I object to the WestConnex M4-M5 Link proposals as contained in the EIS application  
 # SSI 7485, for the reasons set out below.

Application Number: SSI 7485

Application Name: WestConnex M4-M5  
 Link

The EIS states in 6.5.8 Darley Road civil and tunnel site (C4) that:

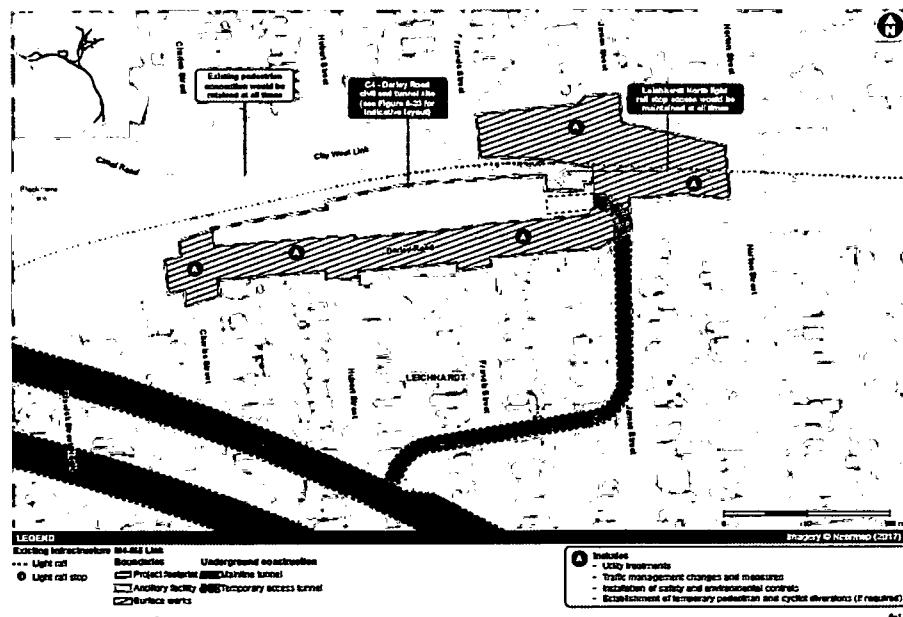
- I object to the EIS because it fails to describe the temporary changes to Darley Road, Leichhardt to enable access to and from the ancillary facility that would likely be required in relation to the Darley Rd site and instead allows for the final plan to be decided by the contractor.

It is not clear how continued access, pedestrian and cyclist movement will be preserved and I am concerned that the impacts have not been correctly identified and assessed by the proponent.

Figure 6-4 Project Footprint – Map 2

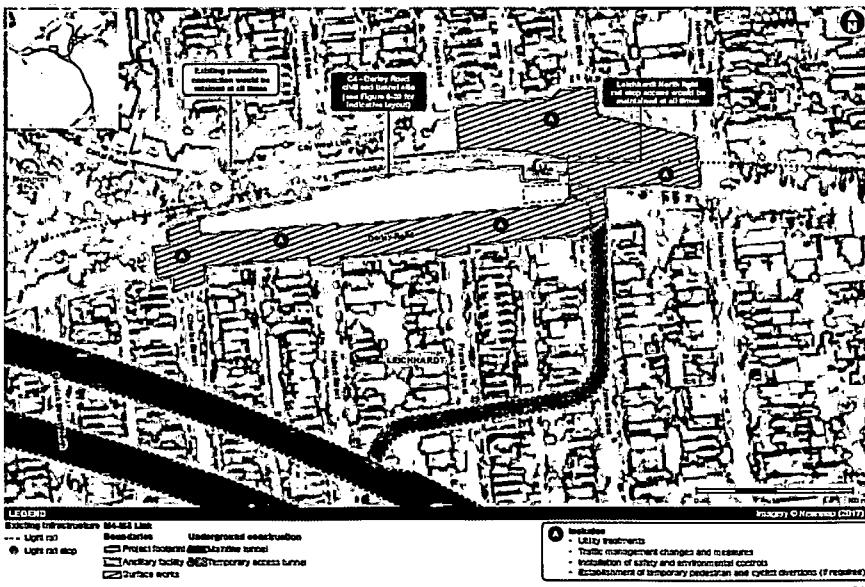
- I object to the EIS because it does not guarantee that the existing access to the Leichhardt North light rail stop would be maintained at all times. Fig 6-4 indicates that only the eastern access will be maintained. This greatly disadvantages the elderly and disabled who have to walk up a steep hill to the eastern access. If the proponent cannot guarantee access to the Leichhardt North light rail stop from the existing entry points or from points that are accessible to all then the Darley Road, Leichhardt construction site should be abandoned. The proponent should be directed to find a site where its operations will not impact on users of the Light Rail.

Figure 6-4 Project Scoping - Map 2

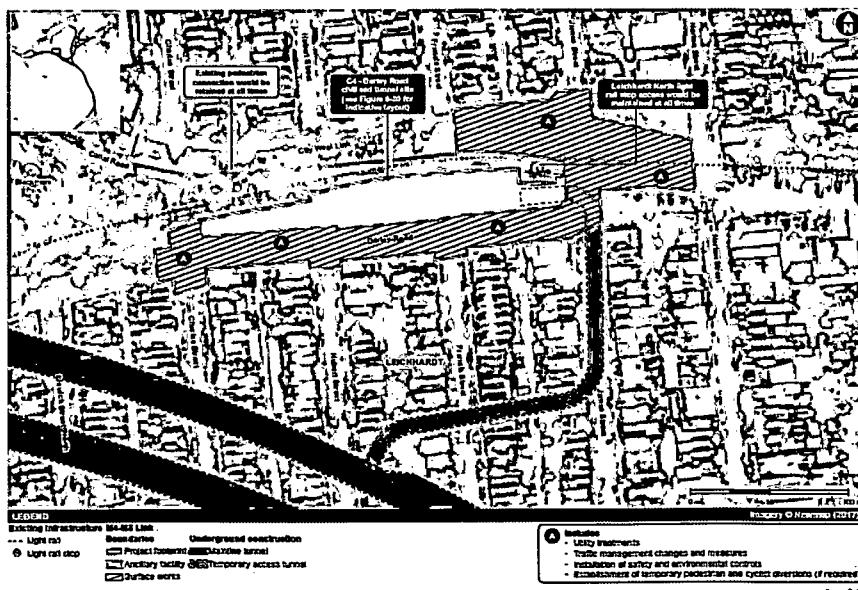
- I object to the EIS because it does not guarantee that the existing access to the Leichhardt North light rail stop would be maintained at all times. Fig 6-4 indicates that only the eastern access will be maintained. This greatly disadvantages the elderly and disabled who have to walk up a steep hill to the eastern access. If the proponent cannot guarantee access to the Leichhardt North light rail stop from the existing entry points or from points that are accessible to all then the Darley Road, Leichhardt construction site should be abandoned. The proponent should be directed to find a site where its operations will not impact on users of the Light Rail.

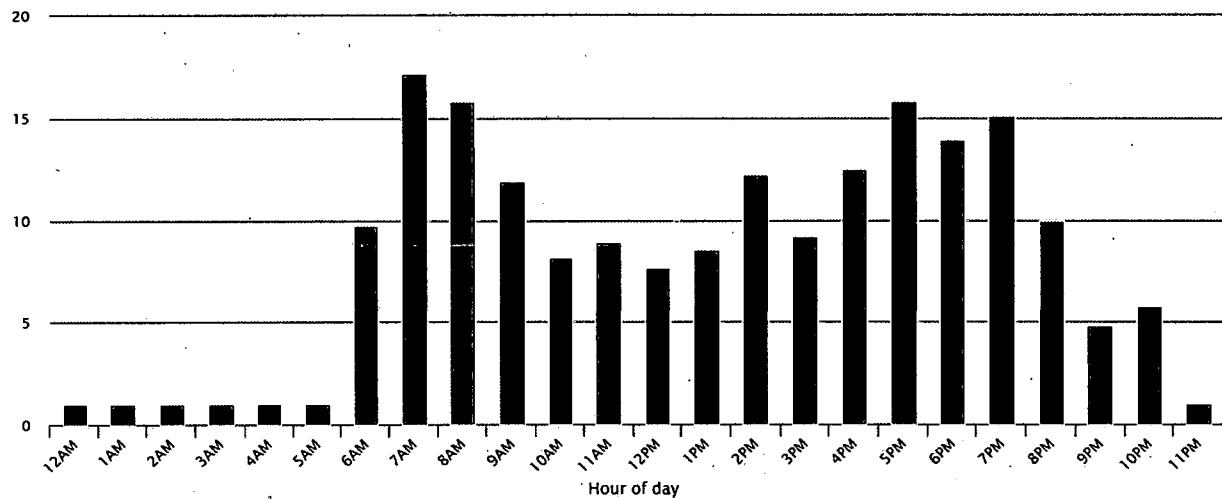
The attached extract from Webtrak shows that Darley Road, Leichhardt and adjacent streets are directly under the flight path.

Airservices Australia reports that in April to June 2017 the number of average daily noise events over 70 dBA. In Leichhardt this is an average of 16-17 per hour over the peak morning period and 16 per hour in the early evening peak period.

The EIS states in 6.5.8 Darley Road civil and tunnel site (C4) that:

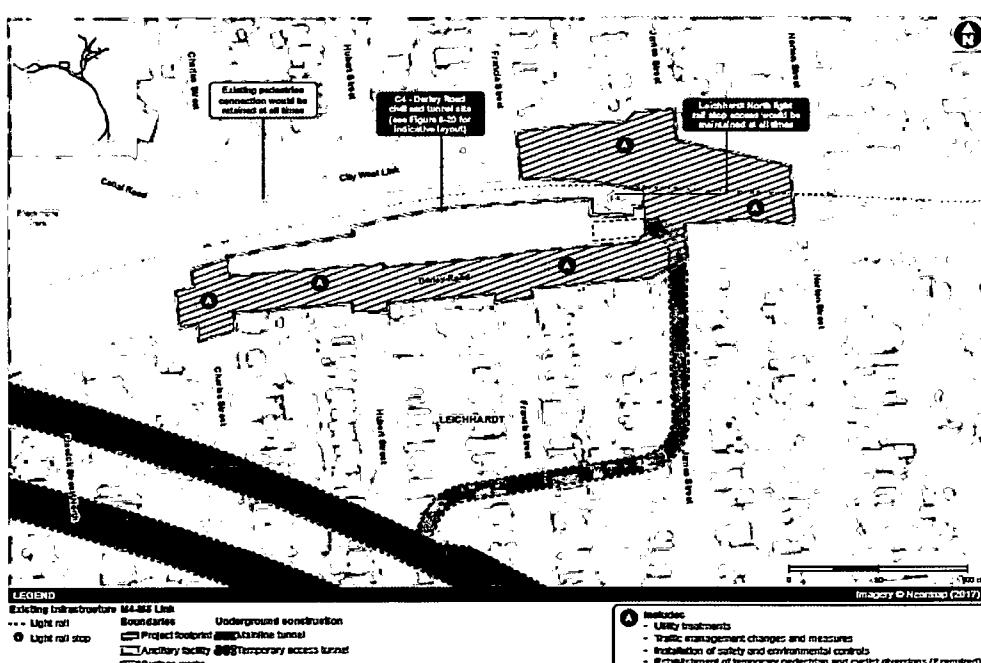
It is not clear how continued access, pedestrian and cyclist movement will be preserved and I am concerned that the impacts have not been correctly identified and

Figure 6-4 Project footprint - Map 2

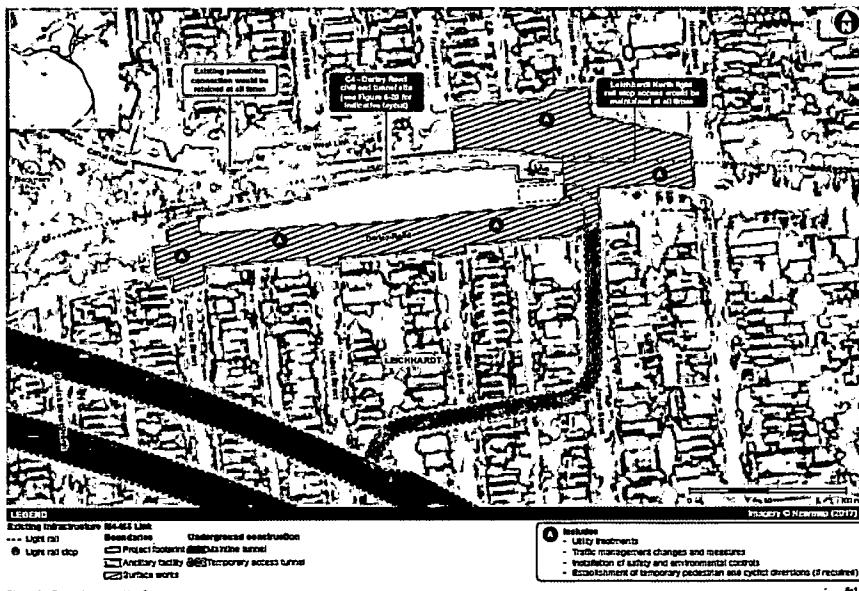
- I **object** to the EIS because it does not guarantee that the existing access to the Leichhardt North light rail stop would be maintained at all times. Fig 6-4 indicates that only the eastern access will be maintained. This greatly disadvantages the elderly and disabled who have to walk up a steep hill to the eastern access. If the proponent cannot guarantee access to the Leichhardt North light rail stop from the existing entry points or from points that are accessible to all then the Darley Road, Leichhardt construction site should be abandoned. The proponent should be directed to find a site where its operations will not impact on users of the Light Rail.
